SAN ANTONIO WATER SYSTEM
DSP Clayton Tank Replacement Project
SAWS Job No. 14-6101
Solicitation No. CO-00028

ADDENDUM NO. 2
October 22, 2015

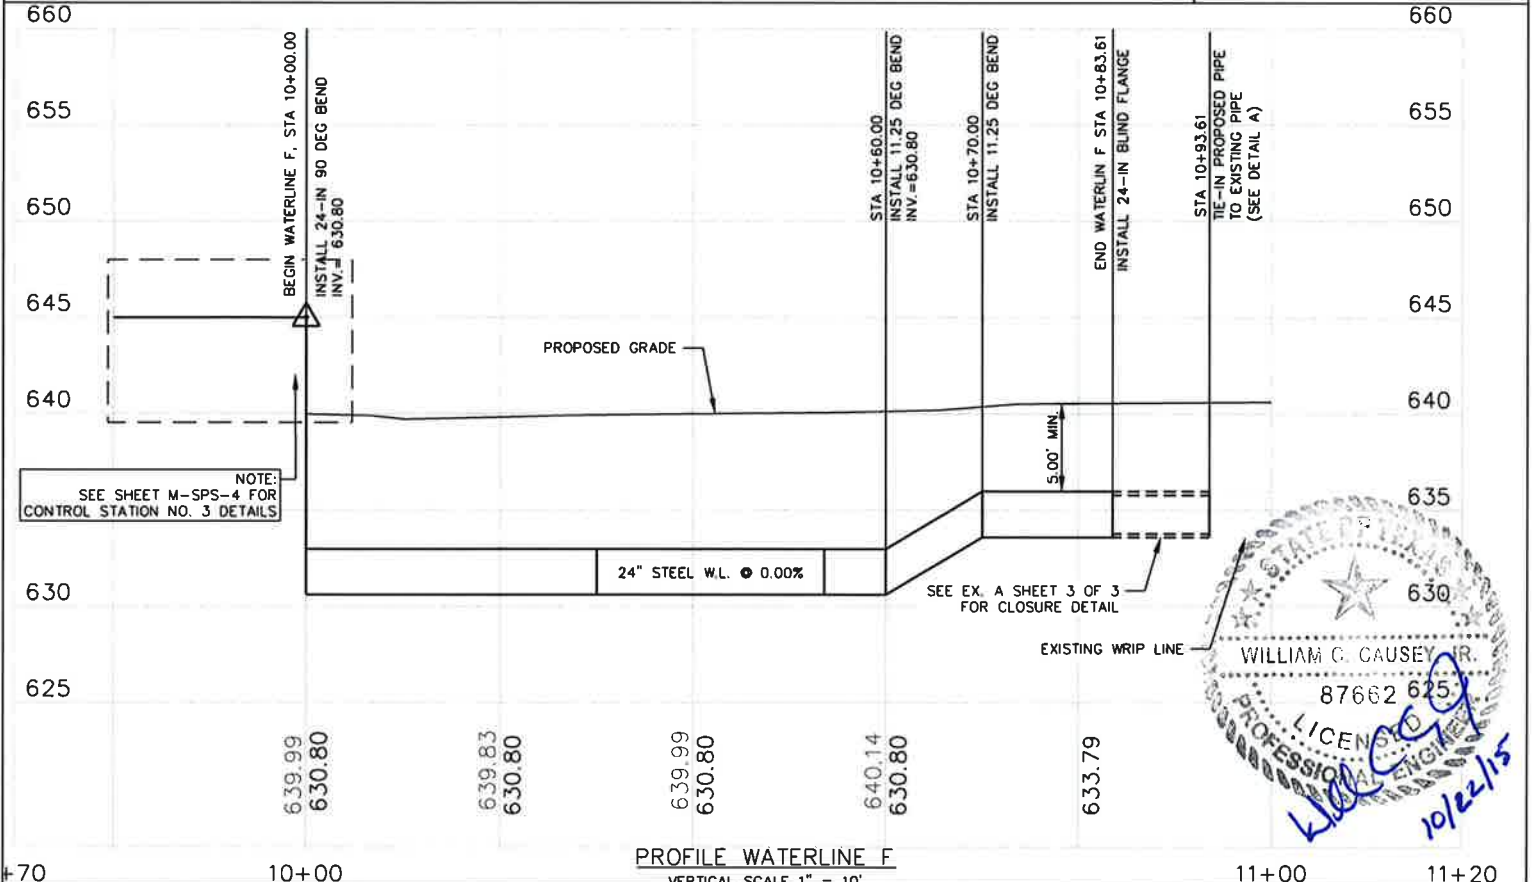
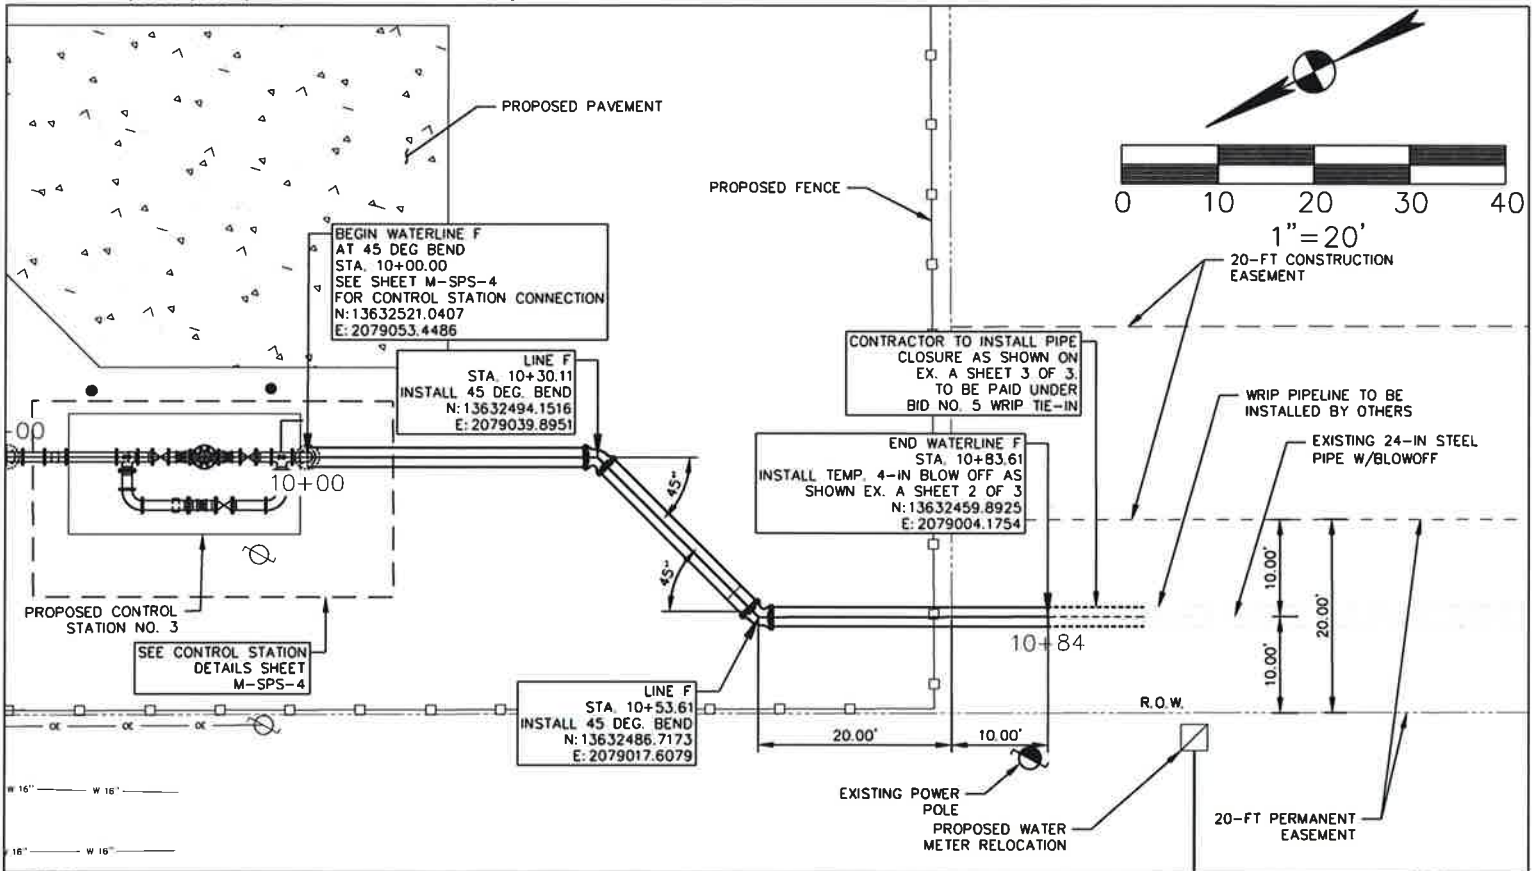
INCLUDE plans and details for the construction of Waterline “F” as shown in Exhibit A of Addendum No. 2. Waterline “F” shall consist of the construction of a 24” steel pipe from Control Station No. 3 to ten feet beyond the Somerset Facility property line as shown in Exhibit A. Waterline “F” shall be subsidiary to Price Item No. 1 – Somerset Facility Improvements and Price Item No. 5 – WRIP Line Tie-In.
